Agenda Item: **U10-001/U10-002/CV10-003 6700 Riverside Drive**, Request for a use permit for the expansion of the existing retreat facility, a use permit to establish a cemetery (columbaria), and concurrent variance(s).

Rezoning Petition No. U10-001/U10-002/CV10-003

PROJECT:
 ST. IGNATIUS HOUSE
 SITE IMPROVEMENTS
 LAND LOTS 130 & 169
 17th DISTRICT
 SANDY SPRINGS, GEORGIA

SITE LAYOUT PLAN
 SCALE: 1"=50'-0"
 DATE: 02/1/2010
 DRAWN BY: DP
 PROJECT MANAGER: MW
 QA/QC CHECK: OD

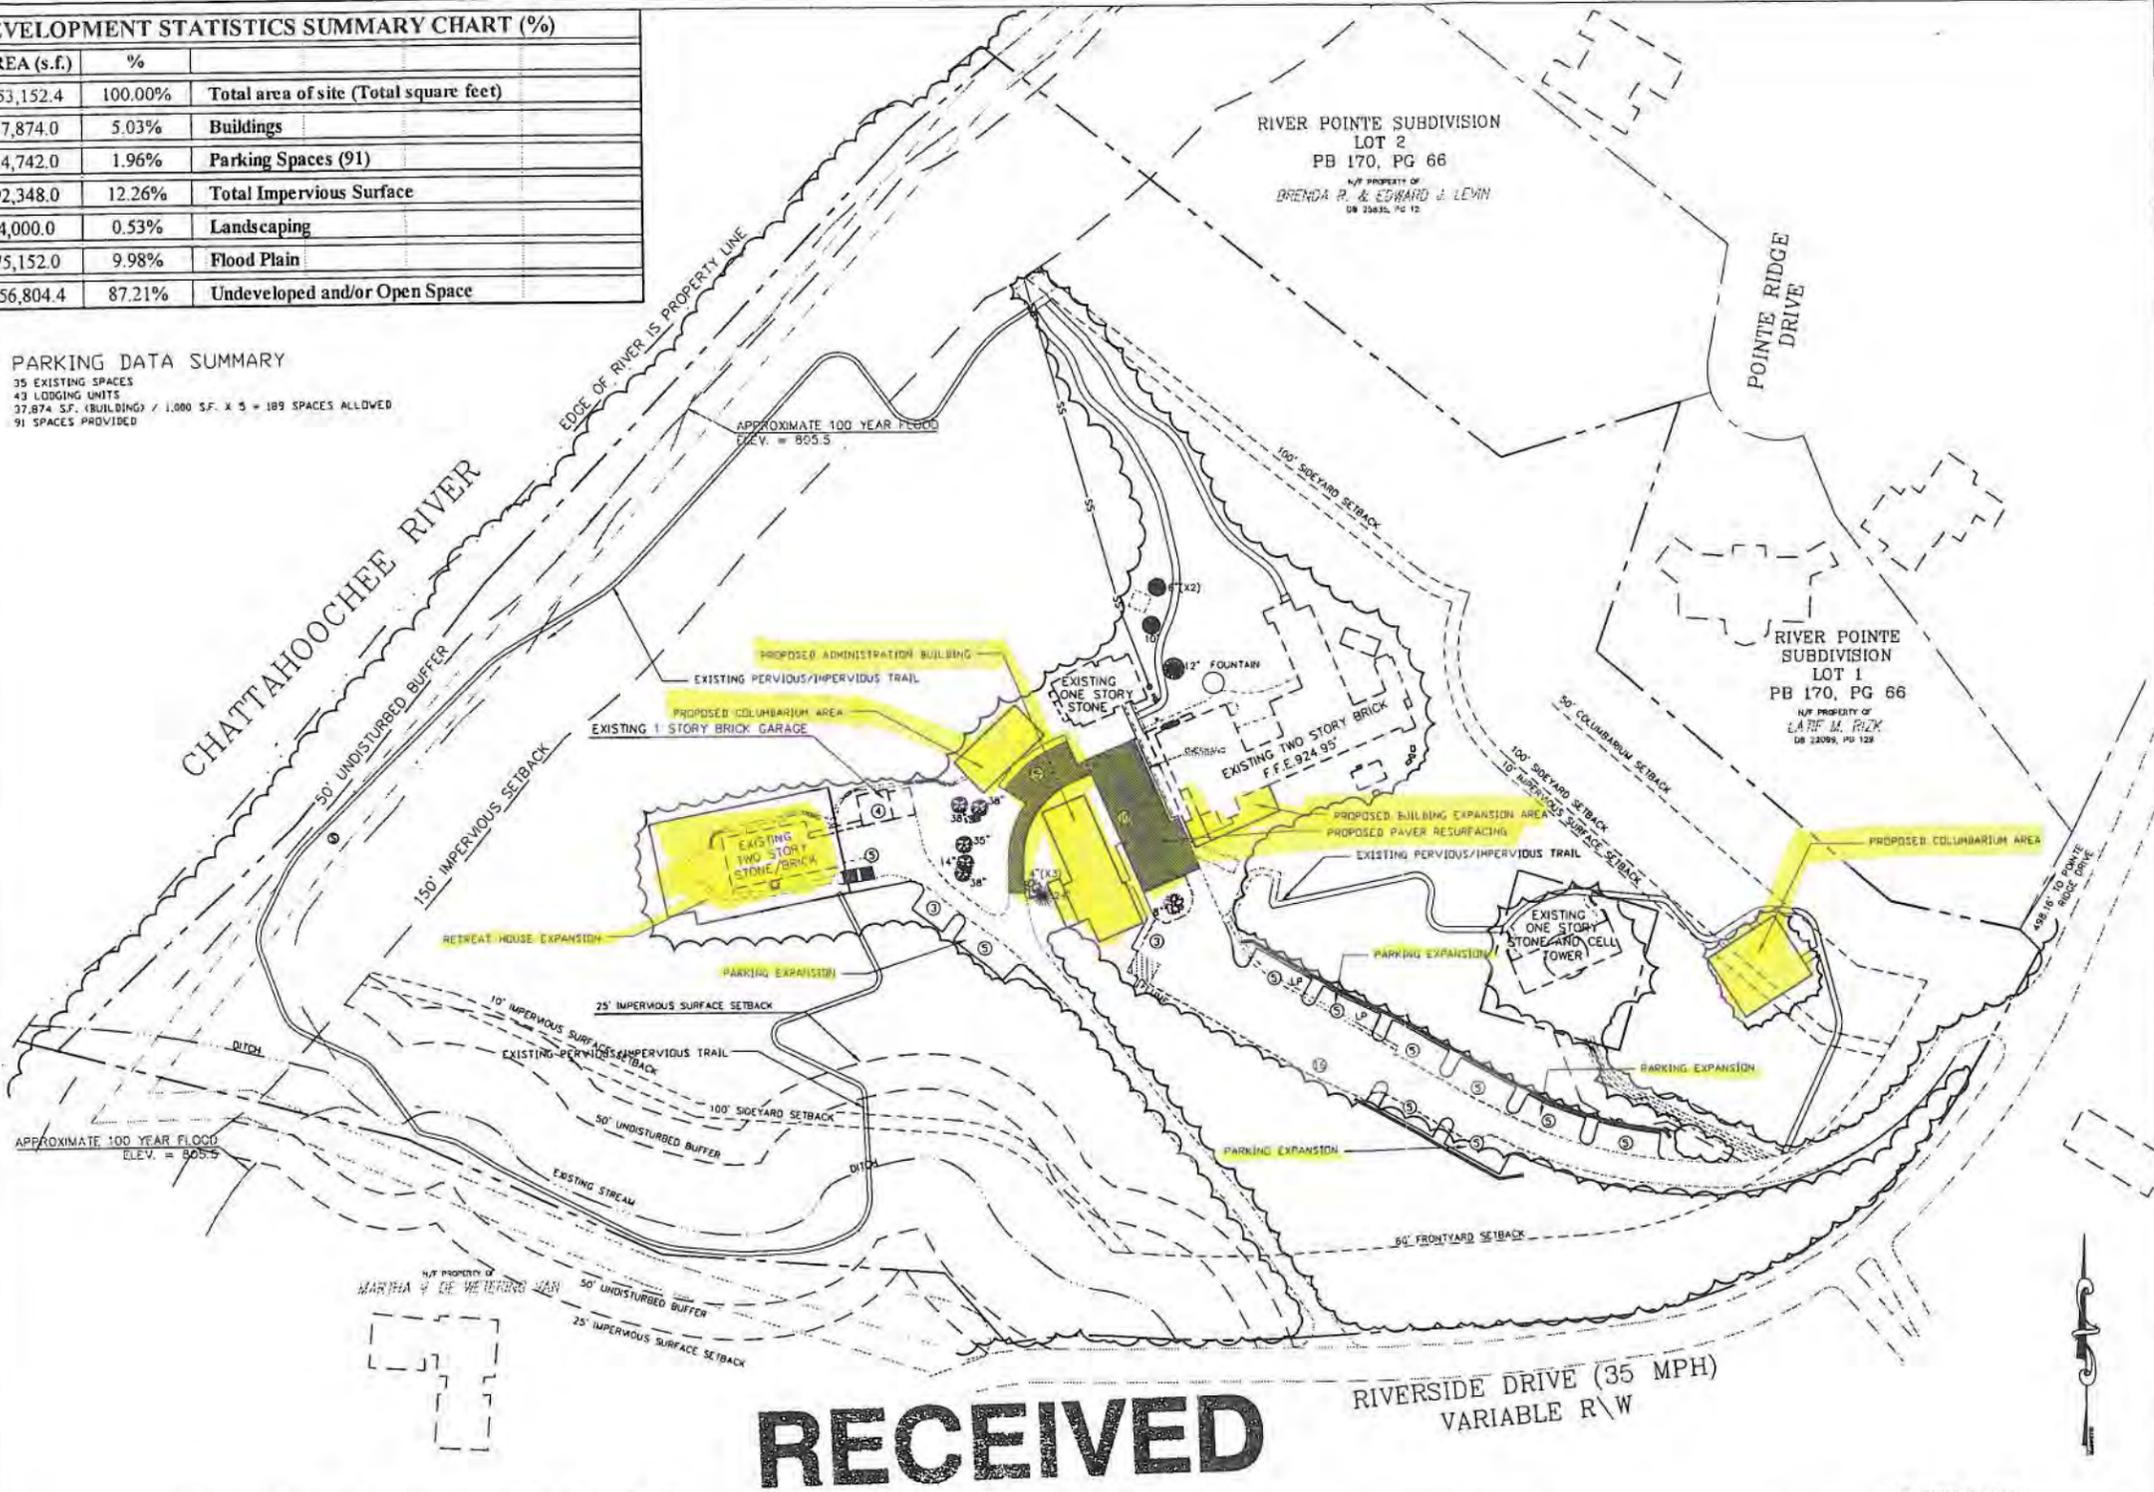
The greater number of parking spaces required based on the above is 189. Therefore, the applicant is requesting a concurrent variance to allow 91 spaces where 189 are required.

The staff has reviewed the information provided and is of the opinion approximately 77 parking spaces, at most, would be needed on a daily basis, where 91 spaces are proposed.

1. Variance from Section 19.4.28.B.9 of the Zoning Ordinance to permit 91 parking spaces where 189 are required.

The staff has reviewed the information provided and is of the opinion approximately 77 parking spaces, at most, would be needed on a daily basis, where 91 spaces are proposed. Therefore, based on these reasons, the staff recommends APPROVAL of the variance to permit 91 parking spaces where 189 are required.

- c. Variance from Section 19.4.28.B.9 of the Zoning Ordinance to permit 91 parking spaces where 189 are required. No offsite parking or street parking will be allowed. (CV10-003) (Variance #1).
